TerraSol Center LLC

**Summary of Proposed Comments to ADEQ On Proposed Renewal of AZPDES
Discharge Permit No. AZ0026387 to South32 Hermosa, Inc.**

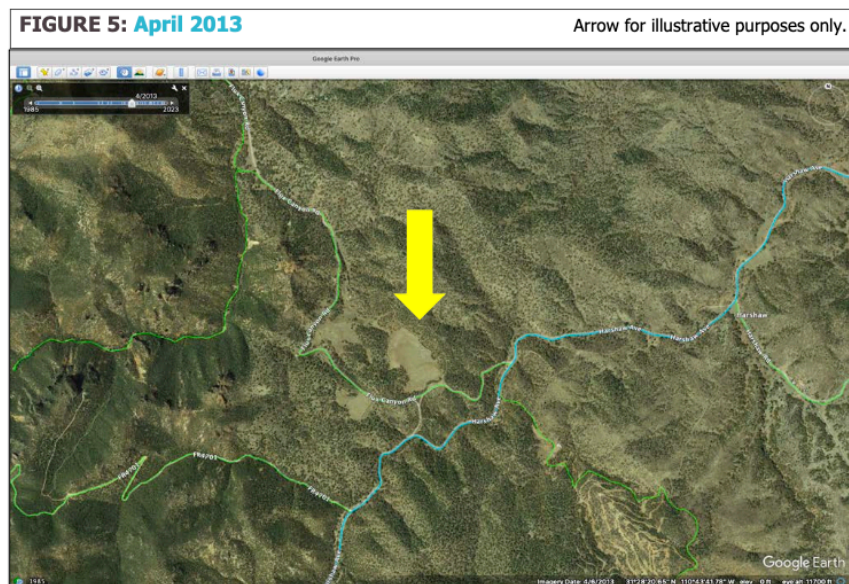
- **COMMENT:** ADEQ’s workaround proposal to only allow discharge from “historic tailings” into Alum Gulch is absurd. It ignores documented facts about how South32 has operated this mine site for years. It also disregards the well-known fact documented by both South32 and ADEQ that the tailings pile and mine seepage from this pile includes dangerous new sources of pollutants. Indeed, the tailings pile has, for years, been used by South32 to hold many tons of new waste rock, exploration rock, treatment plant waste, and potentially acid-generating material. ADEQ’s tortured analysis and conclusion that the only mine seepage that will be discharged to Alum Gulch from the tailings pile will come from historic tailings is wildly inaccurate and misleading to the public. ADEQ must revise this provision – before issuing this renewed Permit.
